Project Number	PC11-597FSI			
Project Name	Frederick Memorial Hospital Parking			
	Garage Expansion			
PC Workshop Date	December 19, 2011

Re: PC11-597FSI: Frederick Memorial Hospital (NAC # 9)

Project Number	PC11-494PSU PC11-496FSI
Project Name	Worman's Mill Preliminary Subdivision Plat Sections 3-6 and Village Center, and Village Center Final Site Plan
PC Workshop Date	December 19, 2011

Re: PC11-496FSI – Worman's Mill Village Center Final Site Plan (NAC #4)

PZ-11-00496 **FINAL SITE PLAN**

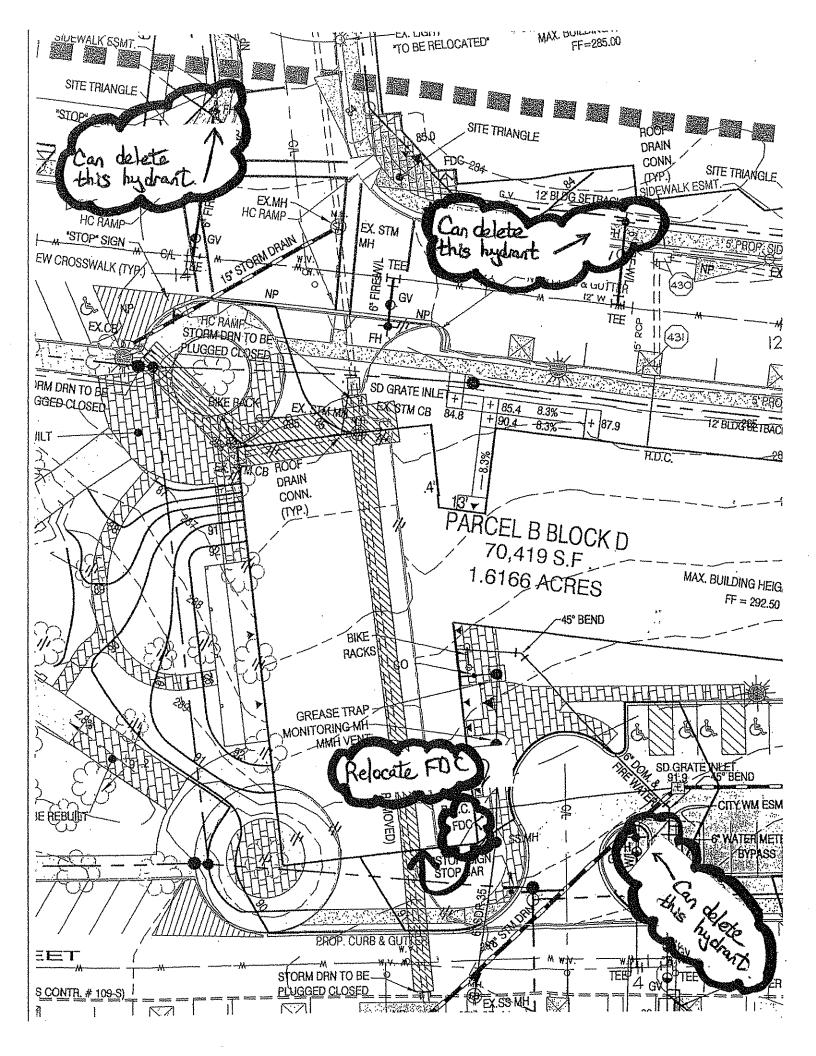
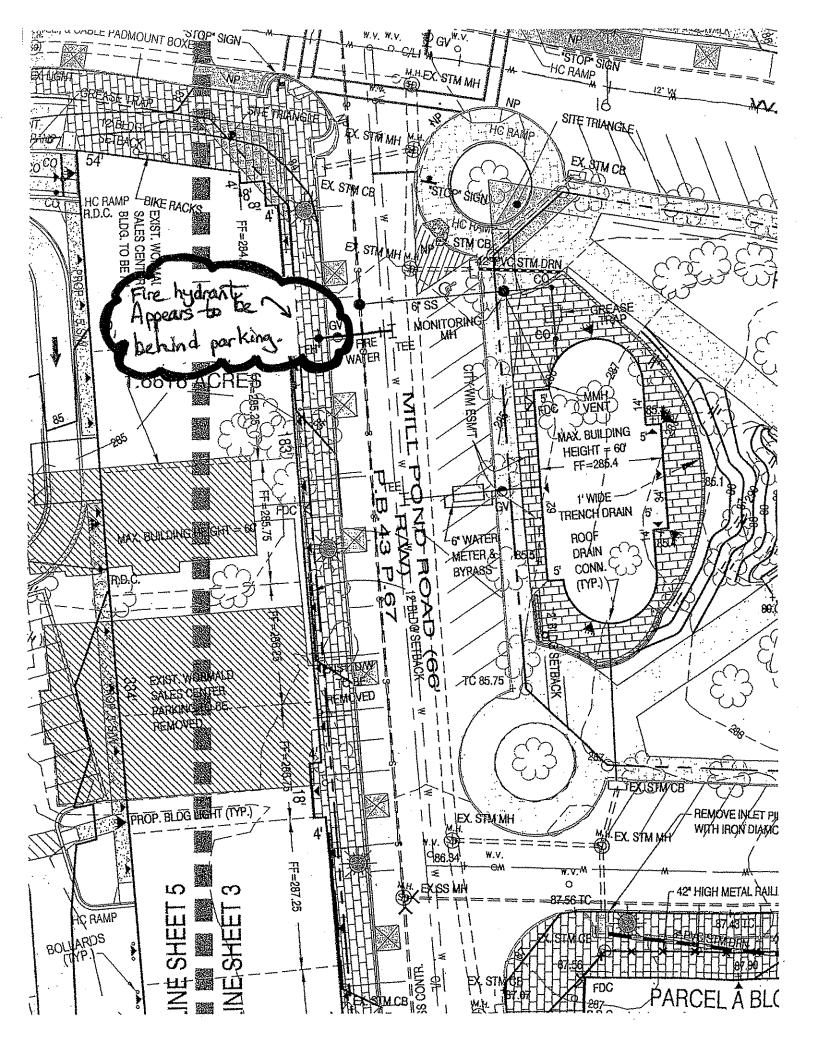
- 1. Remove striping for parallel parking spaces. Typically only needed for metered and/or HC spaces.
- 2. Relocate transit stop outside of Waterside Drive/Mill Pond Road intersection.
- 3. Show all-way stop control at Waterside Drive/Mill Pond Road (stop sign and line to be minimum 4 ft. behind crosswalk).
- 4. No parking areas should be delineated with MUTCD sign.
- 5. Relocate mid-block pedestrian crossing on Mill Pond Road at driveway to Mill Pond Road/Merchant Street.
- 6. Locate water meters inside of buildings unless more than one private fire hydrant on site. Cut off valve to be shown at property line.
- 7. Meter serving Parcel A Block C cannot provide service to fire hydrant on adjacent lot (Parcel B Block C).
- 8. Show existing water service to Wormald sales office and abandonment/removal of same to water main.
- 9. Address comments on (attached) plan markup Sheet FSP2.
